Official Transcript of Proceedings
NUCLEAR REGULATORY COMMISSION

Title: Advisory Committee on Reactor Safeguards
 APR1400 Subcommittee

Date: Tuesday, November 14, 2017

APR1400 SUBCOMMITTEE

Reference: Elevations against External Flood

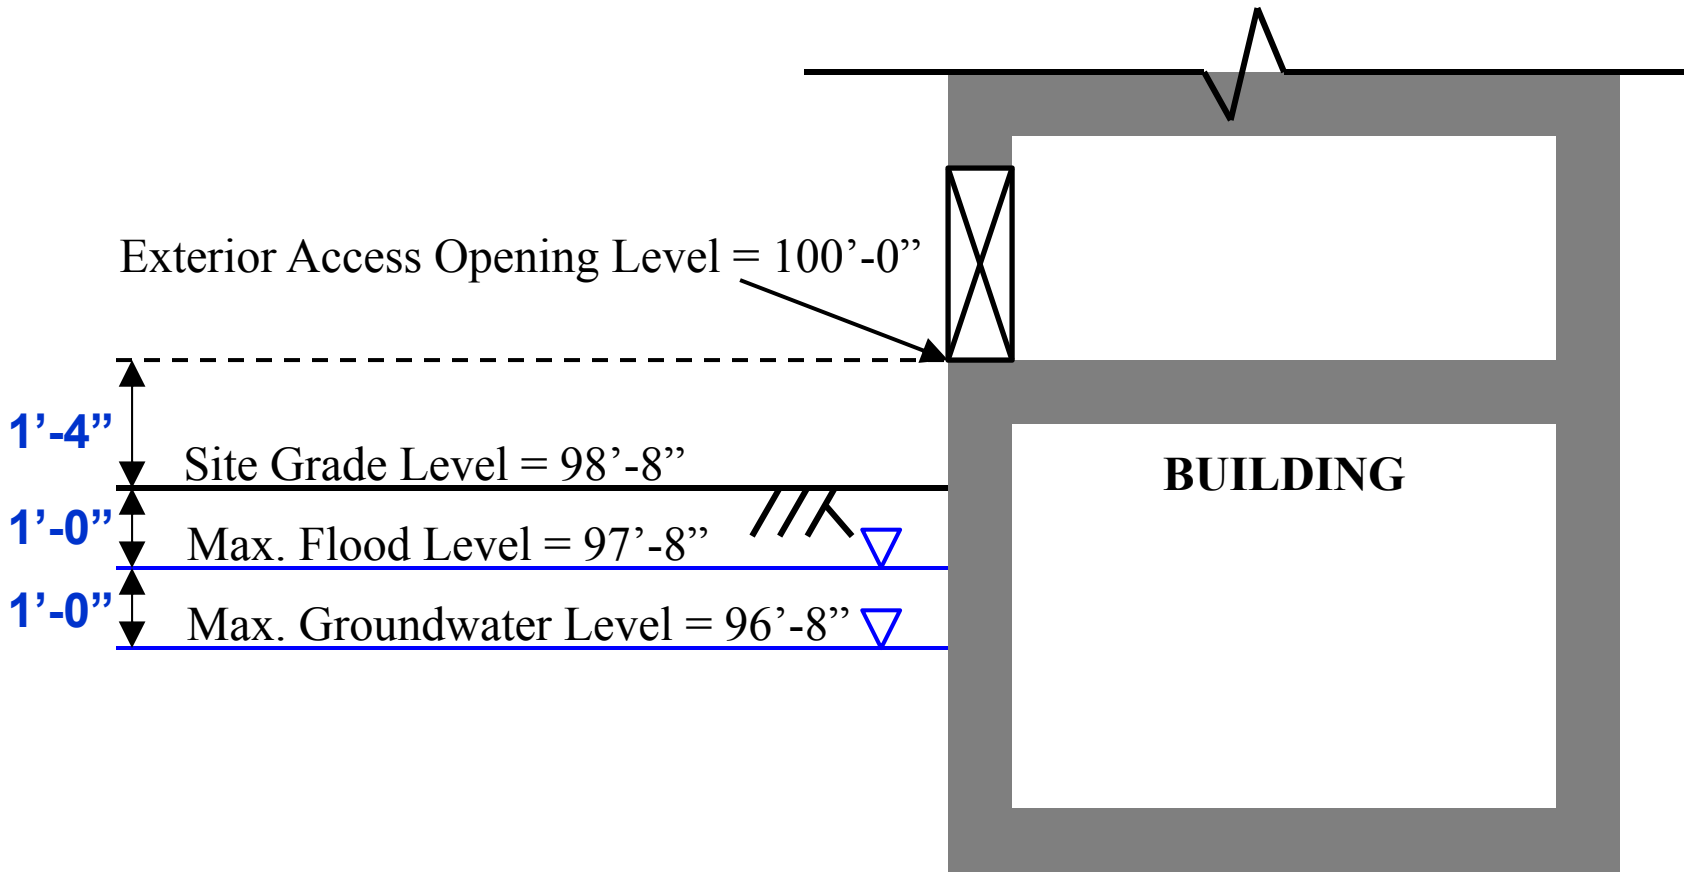
1 This question is related to design basis
2 flood and maximum groundwater level. It was asked
3 to explain which buildings outside the nuclear island
4 need to be protected water level limits, including
5 the turbine generator building, and provide the
6 related COL information item.

7 For this question, KHNP provided the
8 response that, though this is important to safety,
9 safety in Section 3.2 consists of the buildings in
10 the nuclear island and buildings outside the nuclear
11 island, including turbine generator building, as
12 shown in this slide.

16 Lastly, COL Information 2.4(1) states
17 that COL applicant is to provide the site-specific
18 information on flood protection requirements.
